MEMORANDUM

TO: Director of Planning **YOUR REF: F15-0228 (PAD15-0001)**
ATTN: Kristen Augustine, Planning Officer
FROM: Director of Environment
DATE: **18 November 2015**

SUBJECT: **Cayman Enterprise City PAD Application**

LOCATION: **21B/28REM1, 15C/29 and 15C/354**

Figure 1: Aerial image showing permitted developments (highlighted in red) and proposed developments (highlighted in blue) within the South Sound drainage basin.

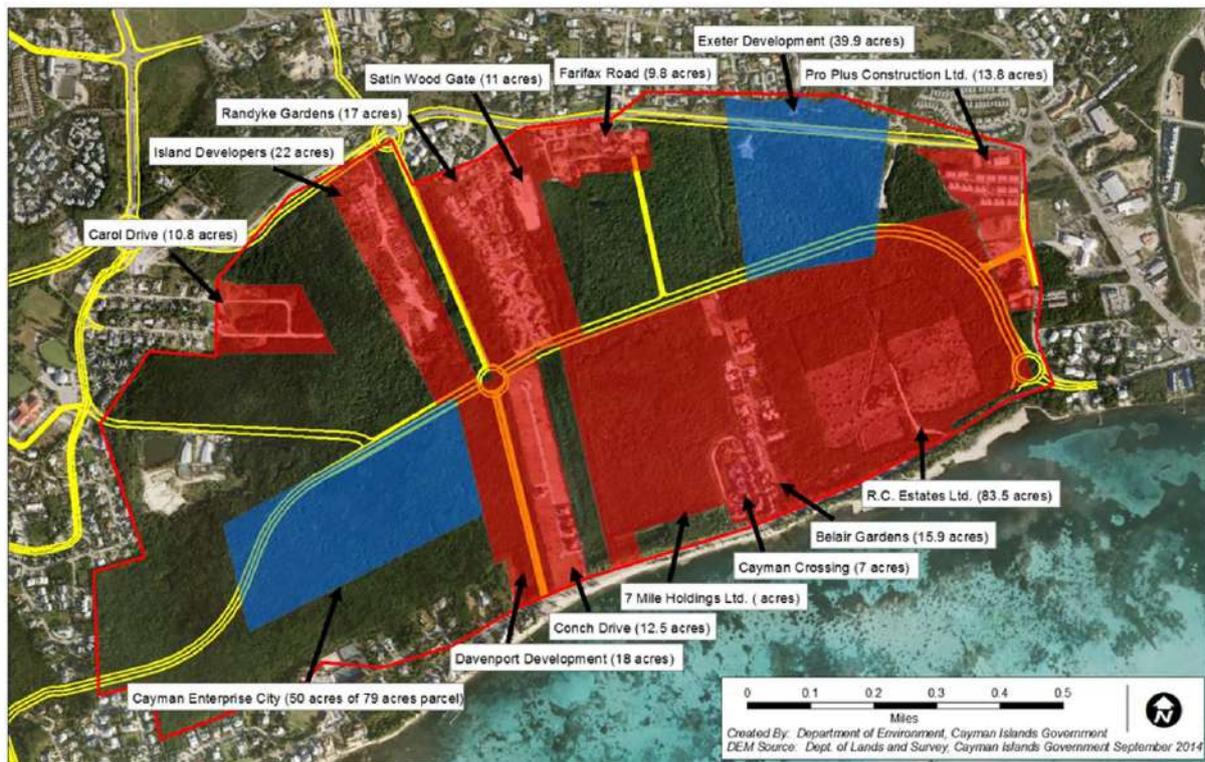
Detailed water level measurements in South Sound have shown that the mean surface water level within the swamp is higher than the mean sea level in South Sound (Davies, J.E. and Giglioli, M.E.C, 1977). During the wet season, impounded rain water remains within the basin and has limited means of escape. As more and more development is brought forward, the implications of removing the stormwater retention capacity of the basin becomes increasingly significant and problematic, due to potential flood risk for properties within the basin. As shown on Figure 1, the current application is only one of a series of developments coming forward in the basin.

Furthermore, the plans which accompany this application show the location of a proposed road leading off Fairbanks Road through the centre of the South Sound basin. The DoE is concerned that unless this is appropriately planned with culverts and stormwater retention basins, this too will further exacerbate the flooding and drainage issues. Whilst the road is outside of the scope of the PAD application, the DoE urges the CPA to carefully consider the future of the road and the further modification to the drainage basin.
